# SERVICE BULLETIN

M-1372

## SPORTSTER CHROME HAND CONTROL LEVER - SAFETY RECALL CAMPAIGN 0156

Figure 1. Hand Control Lever

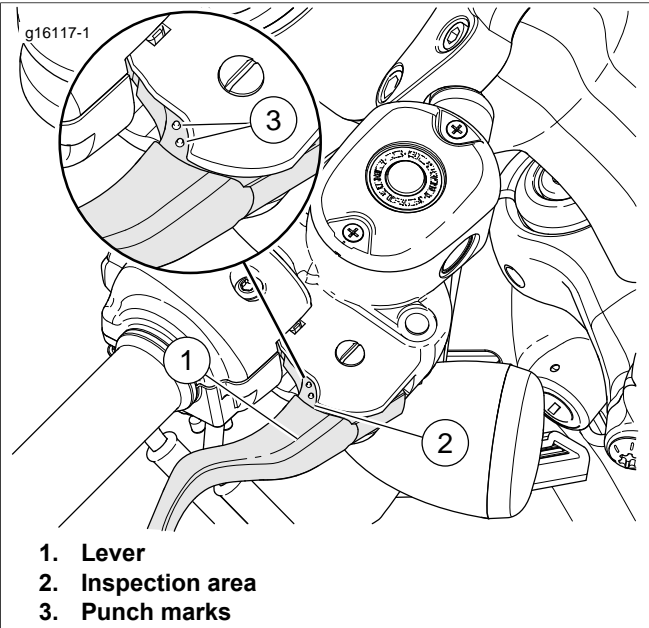
- 1. See Figure 1. Squeeze the front brake lever (1) and observe area (2).
- 2. If two punch marks (3) are present, lever is not involved in recall. If the two punch marks are not present, replace lever with recall kit.

Figure 2. Recall Kit Installation

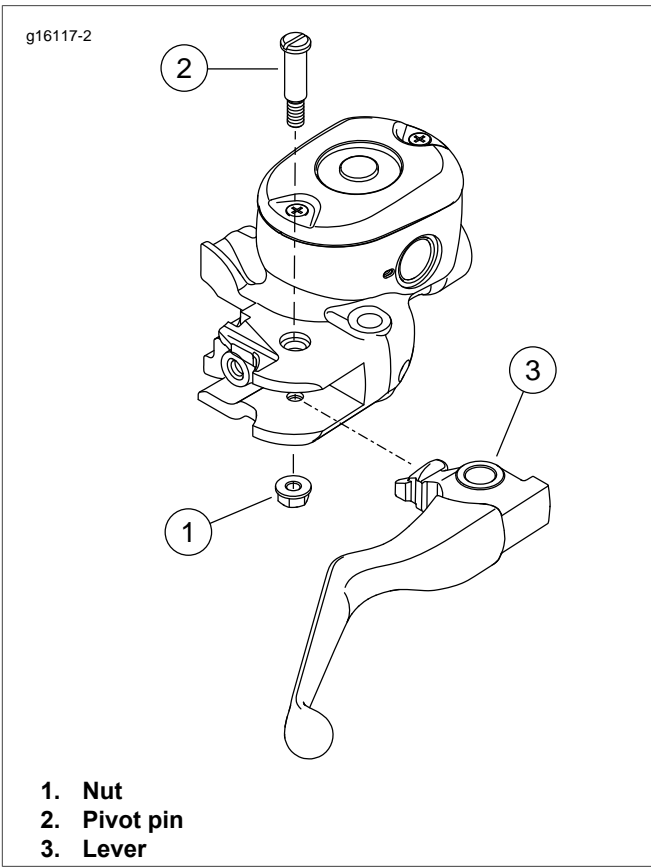
The affected kits have a package date that is earlier than 5/08/2014. Some of these accessory kits may contain brake levers with excessive chrome plating. In extreme cases this could prevent complete return of the master cylinder piston. If the piston cannot completely return and uncover the port-timing hole, fluid pressure will not be relieved. If this condition remains undetected, it could cause the fluid pressure to increase, possibly resulting in a front wheel lock-up, which could lead to a crash.

- 1. See Figure 2. Remove the nut (1) and pivot pin (2).
- 2. Remove the brake lever (3).
- 3. Lubricate the brake lever pivot pin hole and bushing with G40 BRAKE GREASE (Part No. 42820-04).
- 4. Install the **new** brake lever included in the recall kit.
- 5. Install the pivot pin. Tighten to 5-13 **in-lbs** (0.5-1.5 Nm).
- 6. Install the pin nut. Tighten to 44-61 **in-lbs** (4.9-6.9 Nm).
